Our ref: P24-460 Mynydd Maen Request for Further Clarification Response - 14 February 2025

Your ref: DNS/3276725

## Re: Request for Further Clarification of Mynydd Maen Environmental Statement

Figure 1: Abercarn Mountain Road Works Areas

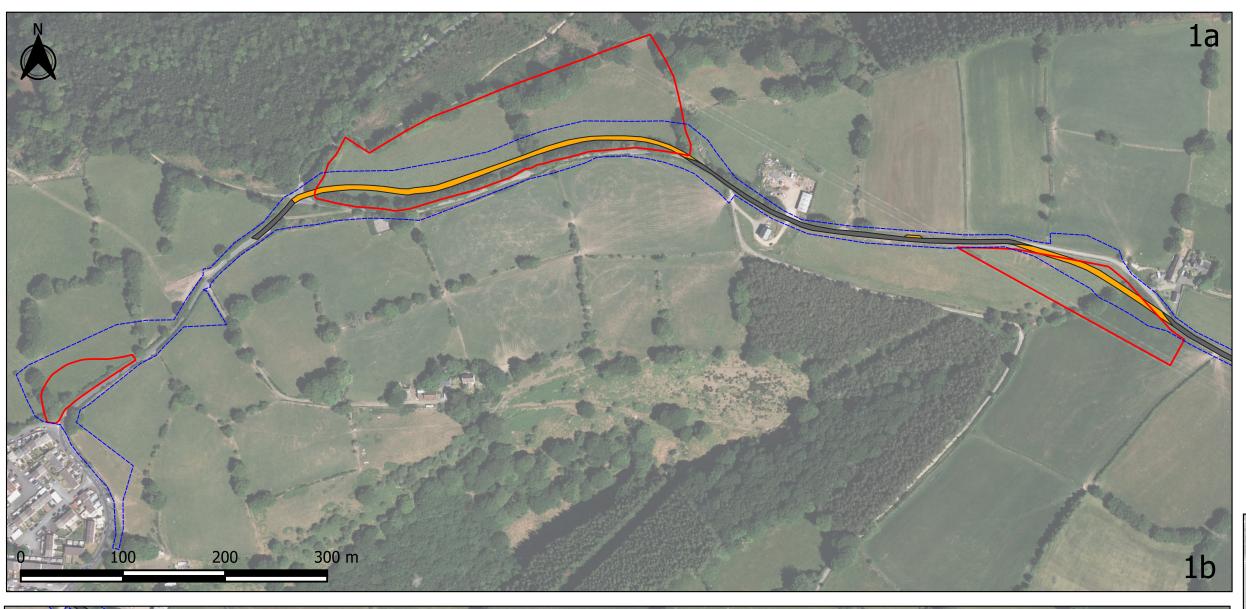
• "The areas for two new tracks and widening works along the Abercarn Mountain Road as shown in Figure 10.3, where hedgerow and/or tree removal may be required, does not appear to be included in the Phase 1 survey."

• "The blue dotted 'Survey Area' line shown on the submitted Figure 6.1 'Phase 1 Habitat Survey Area', referred to in the Ecologist letter, does not include all access works to the Abercarn Mountain Road as stated. Figure 6.1 therefore conflicts with the clarification provided within the Ecologist letter regarding the Ground Level Tree Assessment and subsequent Close Inspection coverage. Further explanation of the reasons for this inconsistency, or its correction is therefore required."

The appended Figure (Figure 1: Abercarn Mountain Road Works Areas) shows the Phase 1 Survey Area, the three plots of the Site boundary adjacent to the Abercarn Mountain Road and the Abercarn Mountain Road with works areas demarcated (at high resolution). In addition, Figure 6.1 has been updated to show the Phase 1 Survey Area along the Abercarn Mountain Road (not shown on that figure previously), for clarity.

The inspector is correct that parts of two of the plots, namely the northern part of the central plot, and the south-western part of the eastern plot<sup>1</sup> fall outside the Phase 1 survey area. While within the Site 'red line' boundary however, they will not be impacted by the proposed works. For further clarity, we can confirm that the Phase 1 Survey Area included all of the proposed works areas along the Abercarn Mountain Road.

The ground level tree assessment covered the whole of the Phase 1 Survey Area. As noted in Section 6.12.17 of the Ecology Chapter of the Environmental Statement, all trees with any potential to support roosting bats along the access route could be thoroughly inspected from ground level (no climbed assessment was required). No evidence of roosting bats was found. The trees that were subject to ground level inspection and were found to have some potential to support roosting bats are shown on Figures 6.2a and 6.2b. Scrub (with no bat roost potential), and any trees outside of the footprint of the works were not inspected.
